ADDENDUM NO. 3
Water Treatment Plant GAC Facility
City of Cynthiana
Cynthiana, Kentucky

**RFI'S FROM CONTRACTORS
ADDENDUM NO. 3**

**WATER TREATMENT PLANT GAC FACILITY
City of Cynthiana
Cynthiana, Kentucky**

SHEET NO.
C-1-1

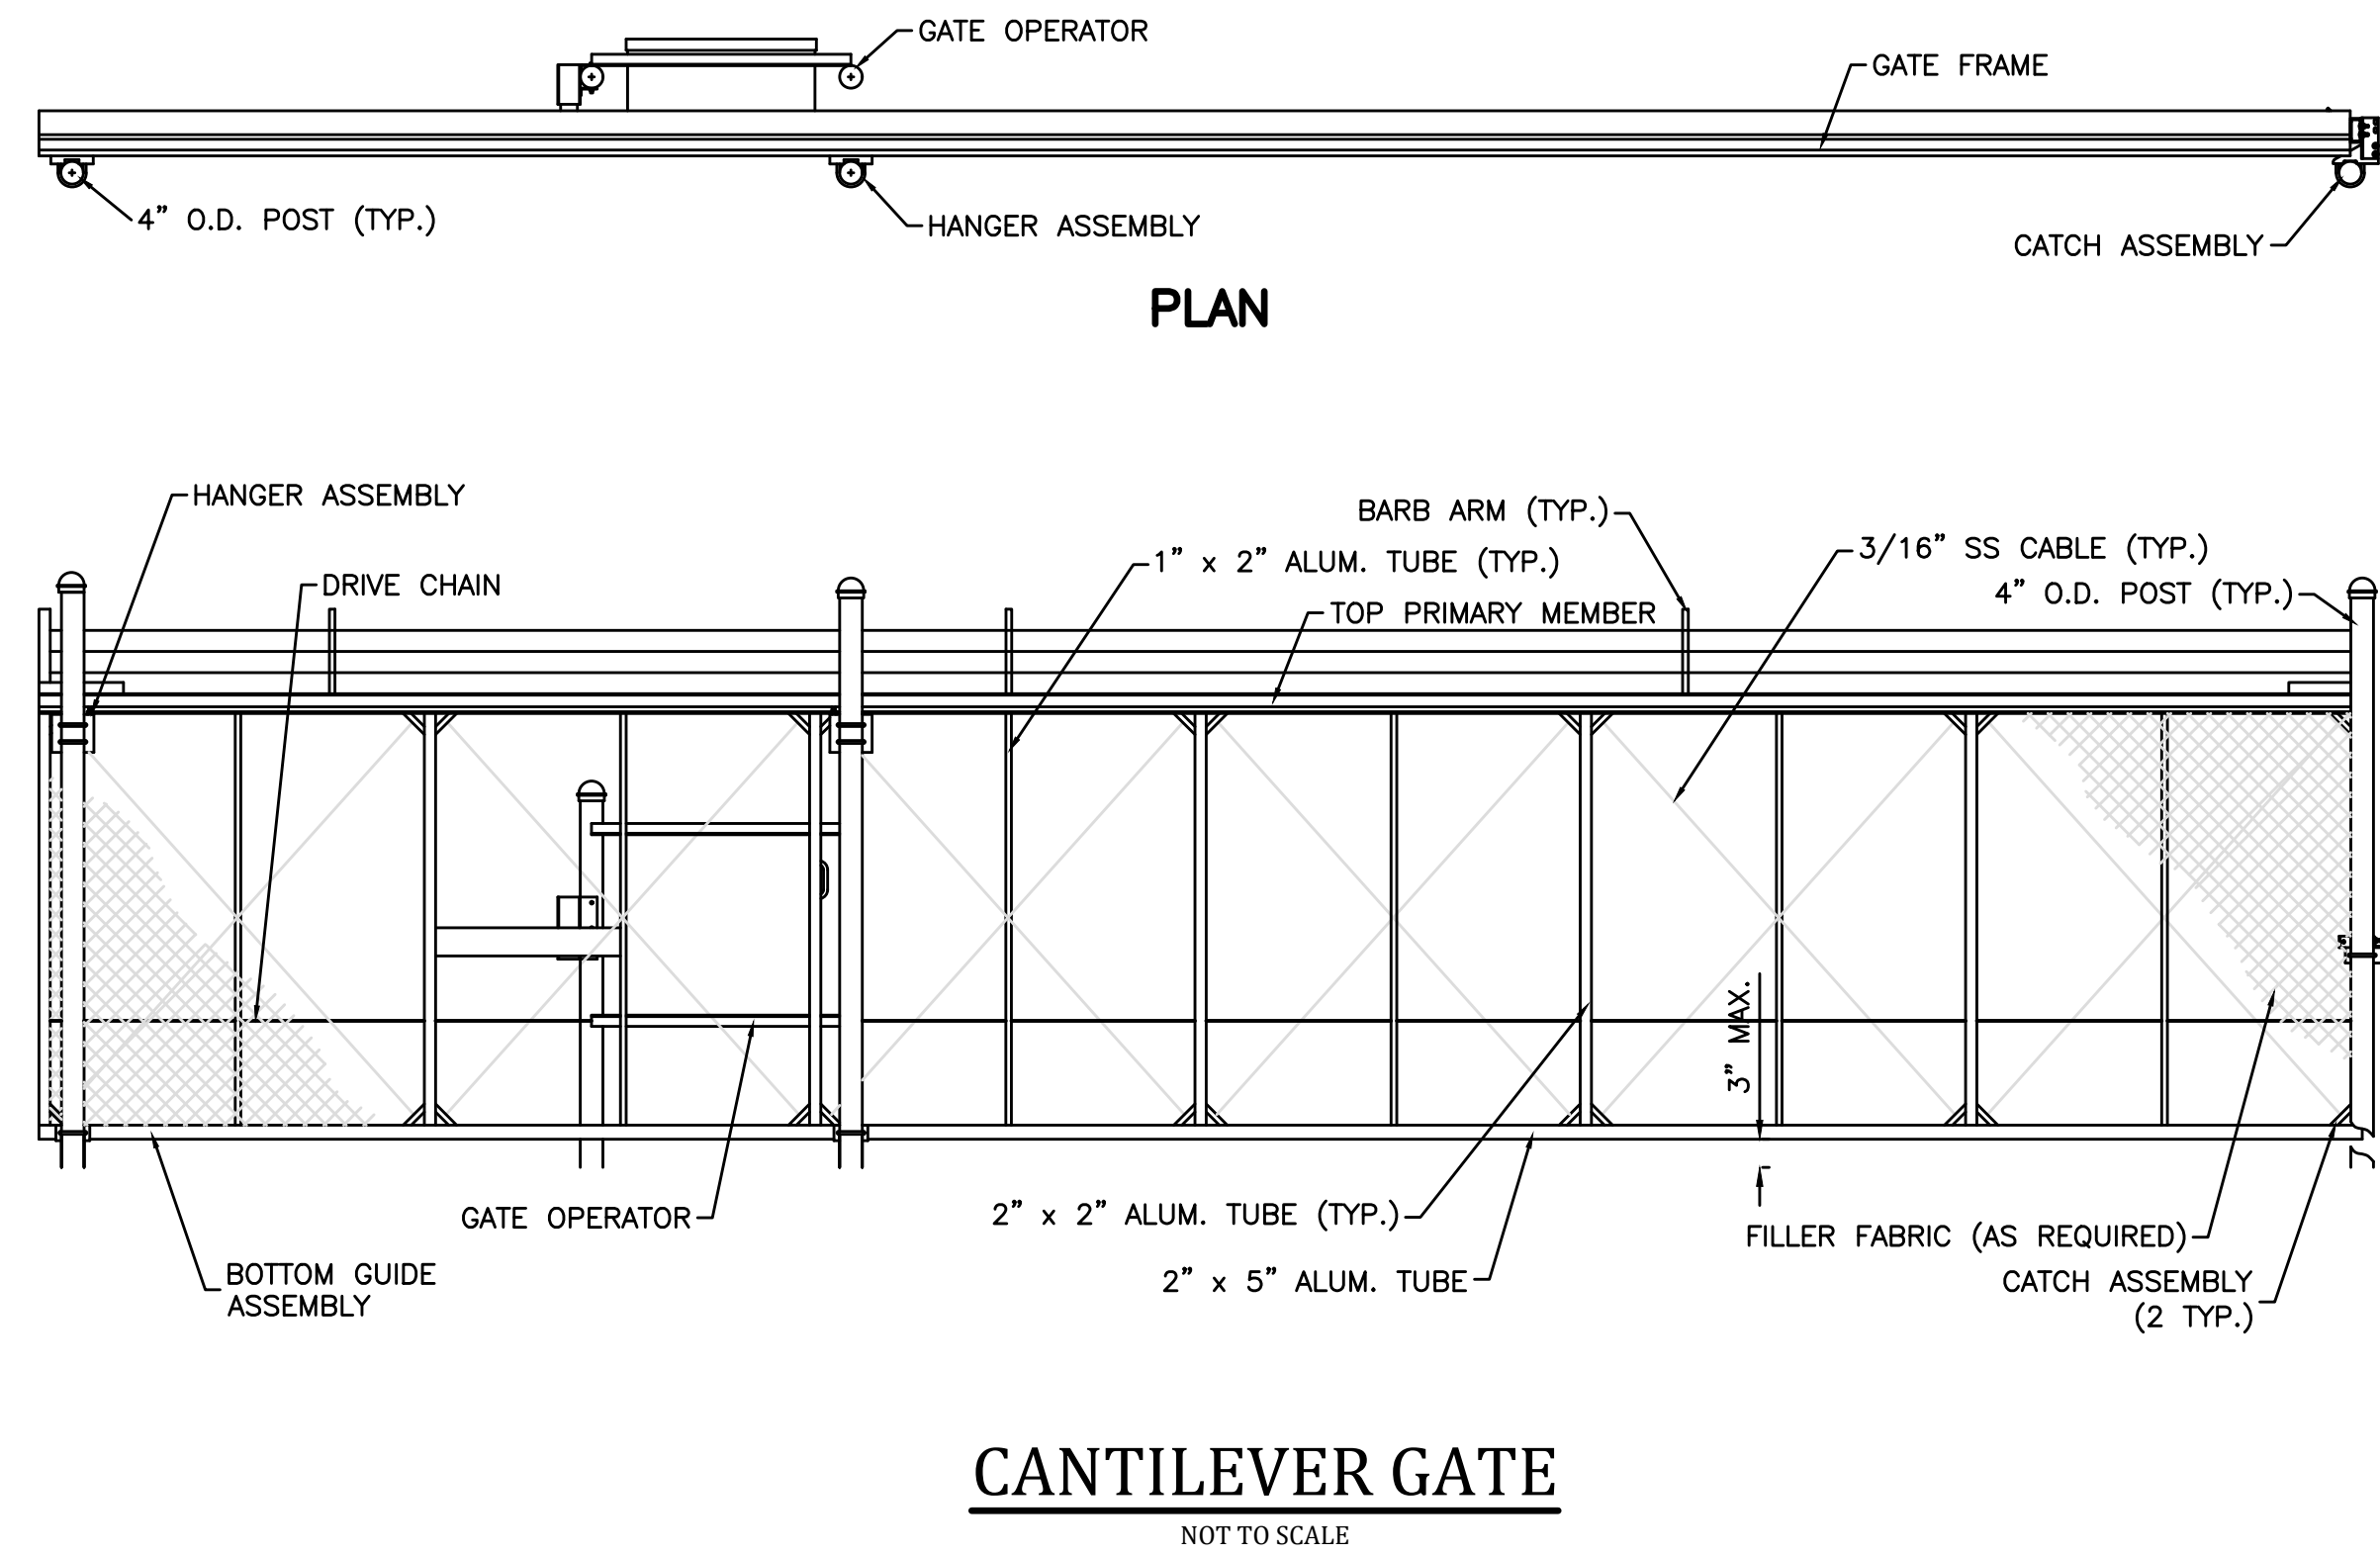
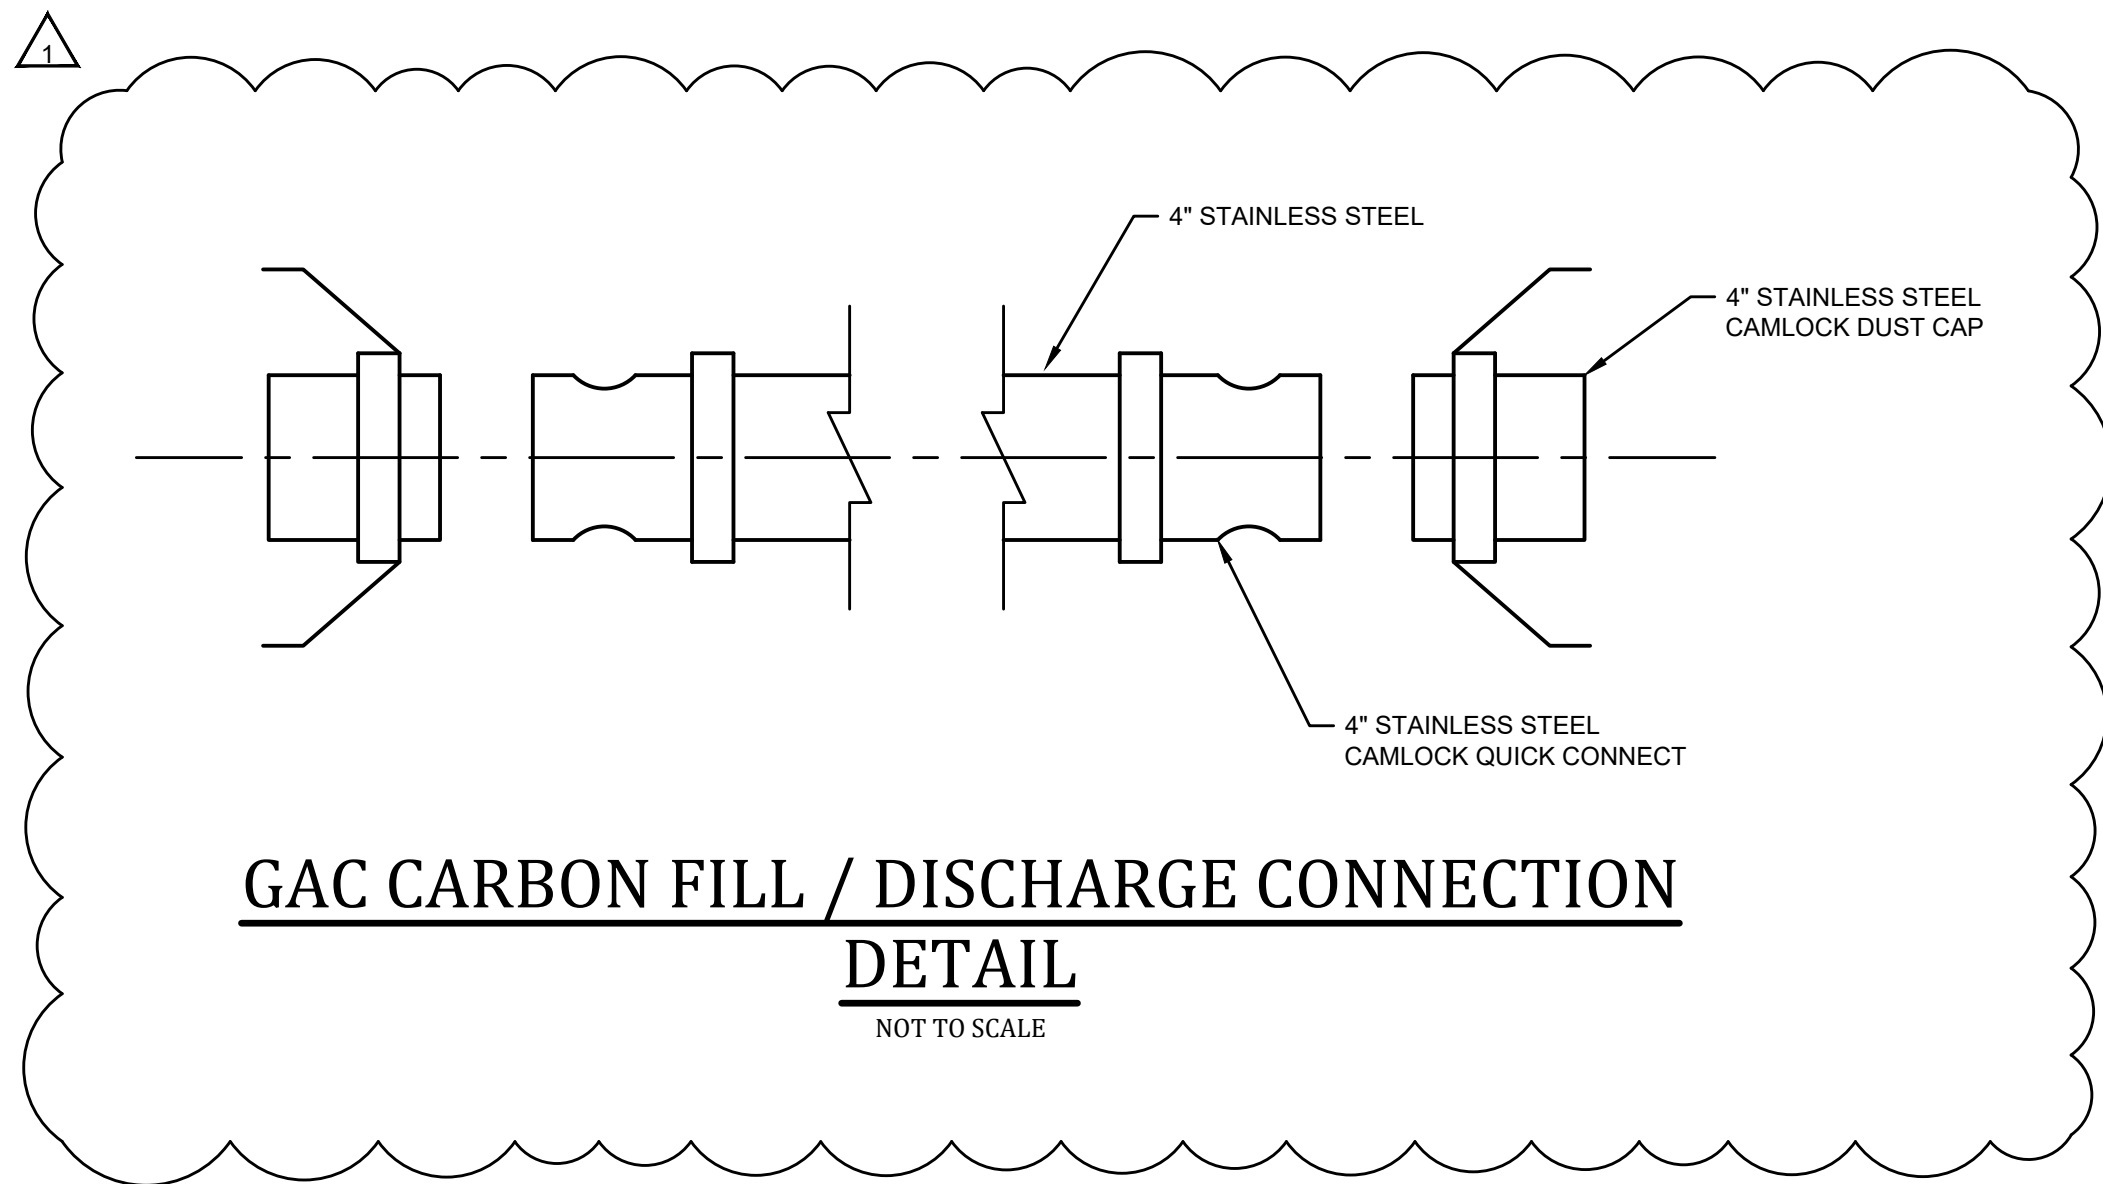
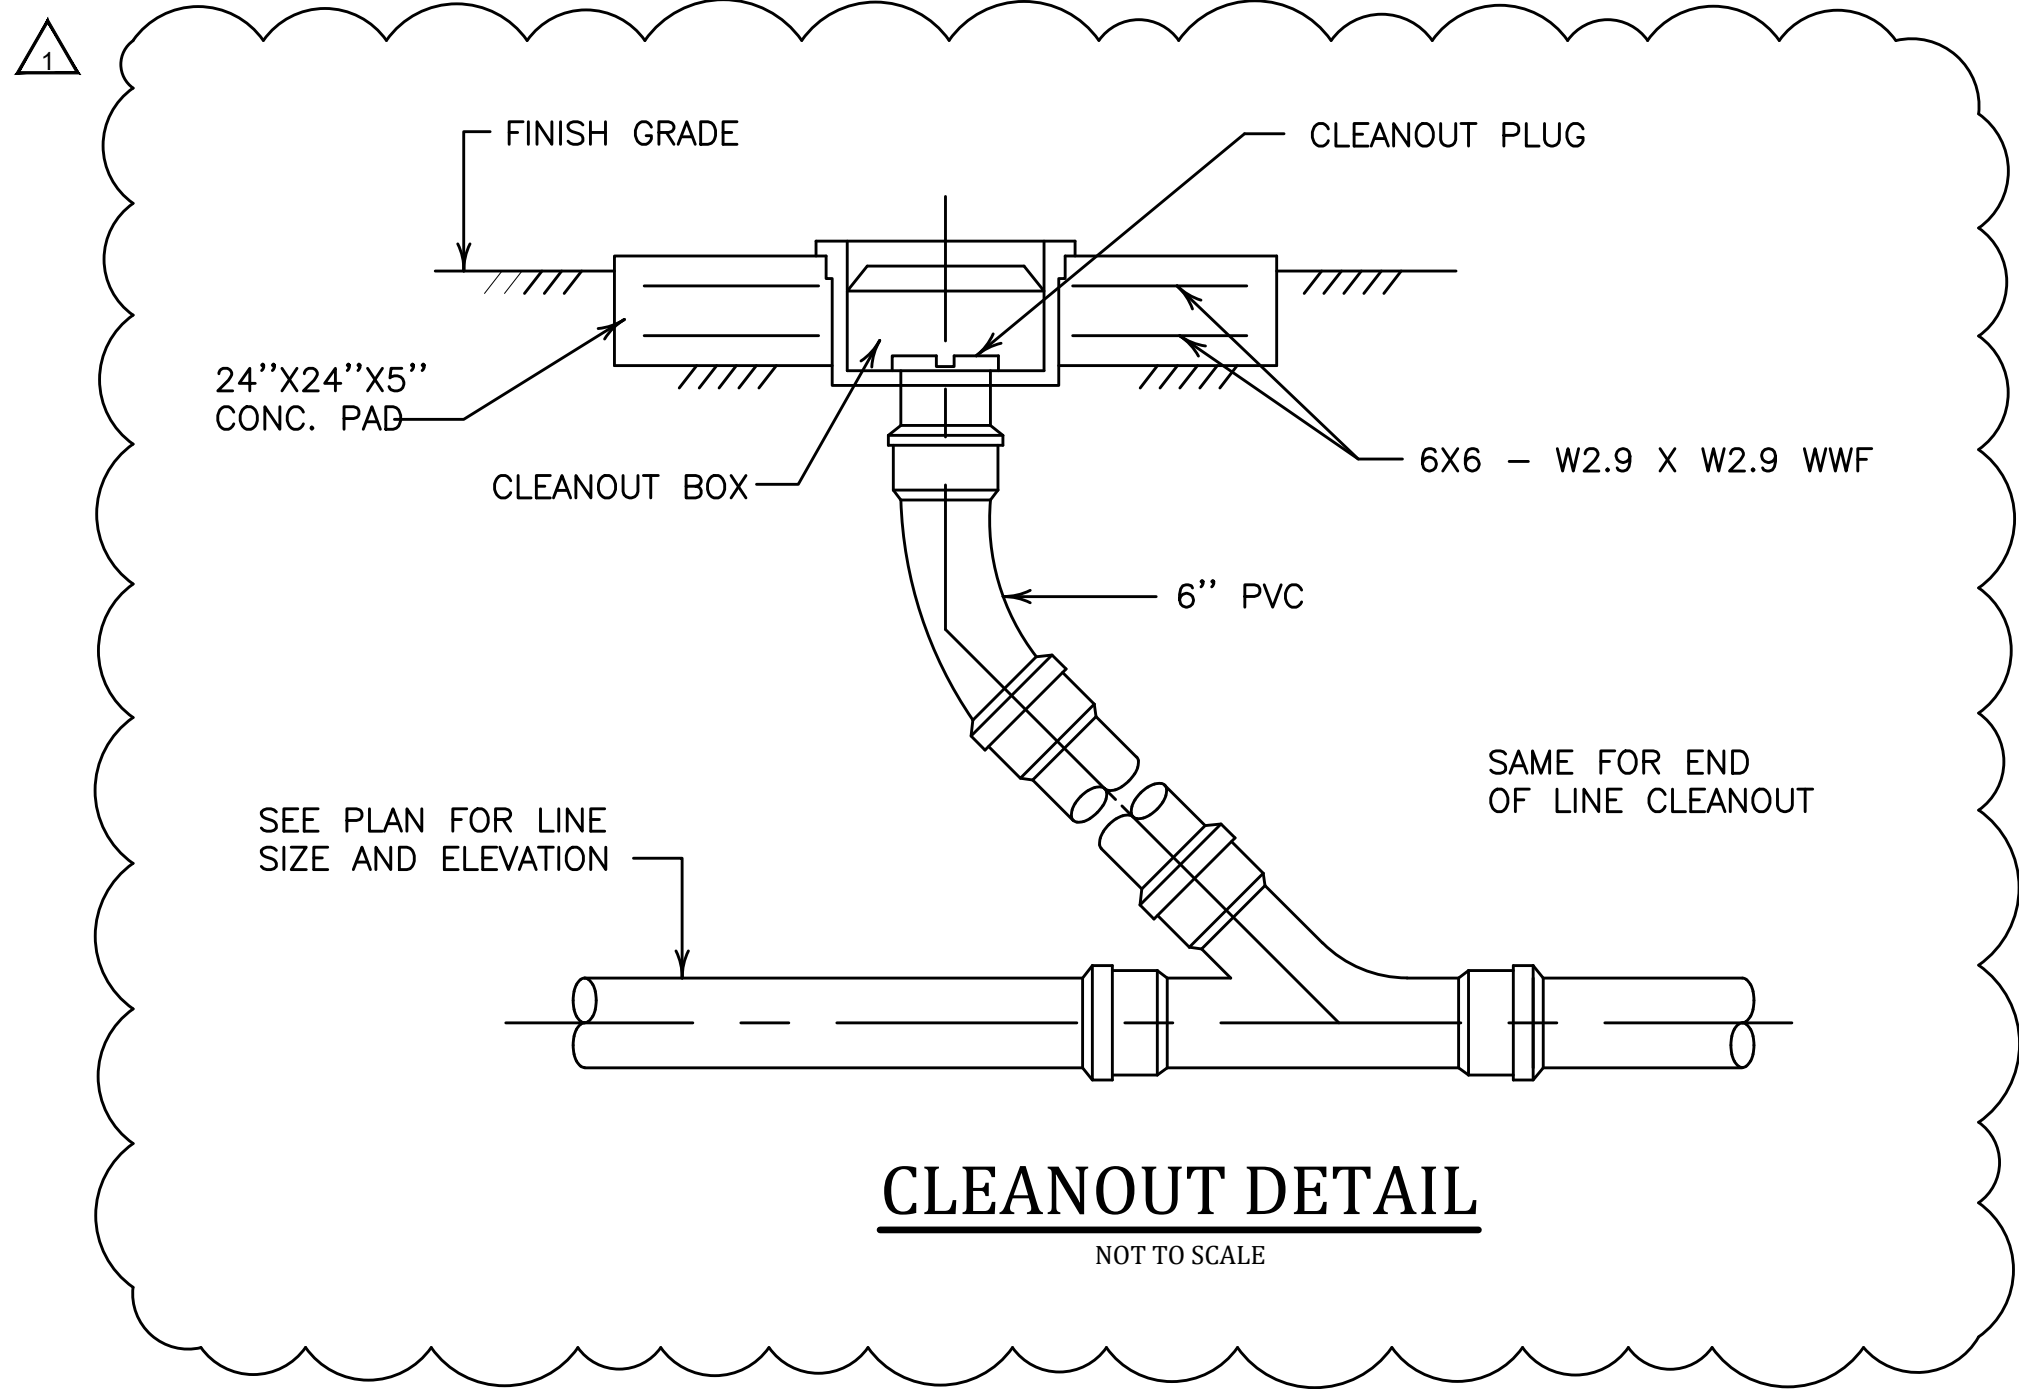
2. *On Sheet C-1-1, Reference Note 6 calls for an "18" Butterfly Valve" to be installed in the unidentified room. On Sheet C-1-4, Reference Note 2 calls for an "18" Butterfly Valve w/Electric Modulating Operator" for the same valve identified above. Please confirm the correct operator for the valve at this location.*

6. *Reference Note 27 on Sheet C-1-1, and Reference Note 17 on Sheet C-1-3 both pertain to "Air Release Valve (Plumb to GAC Wet Well)". Please confirm the correct size of the Air Release Valve.*

7. *On Sheet C-1-1. Reference Note 35 pertains to the "GAC Carbon Fill Discharge Connections – 4" Quick Connect (Typ.) See Detail". Please provide the applicable Detail.*

8. *On Sheet C-1-1, Reference Note 38, and on Sheet C-1-2, Reference Note 14, pertain to "Combination Air / Vacuum Valve". Please confirm the correct size of the Combination Air / Vacuum Valve.*

10. *Information on Sheet I-4 indicates sample lines are to be copper. On Sheet C-1-1, Reference Note 31 calls for "1" PVC Sample Line (Typ.)". Please confirm sample lines are to be PVC.*

14. *Referencing Sheet C-1-1, the 18" GAC influent and effluent DI pipes are shown to be at centerline elevations 703.00 and 704.00, respectively, when tying into the new construction, however, at the tie-in locations to existing 20" FW piping, no inverts or centerlines are provided. Please provide, if available, as-built drawings or approximate existing elevation information for the Existing 20" DI FW lines at the tie in locations.*

RESPONSE: See attached revised plan sheet C-1-1. Reference Note 6 changed to Reference Note 34.

RESPONSE: 2"

RESPONSE: See attached revised sheet SD-2 with Quick Connect detail included

RESPONSE: 2"

RESPONSE: Sample lines shall be PVC

RESPONSE: As-builts indicate centerline elevation of 703.35'. Contractor shall field verify.
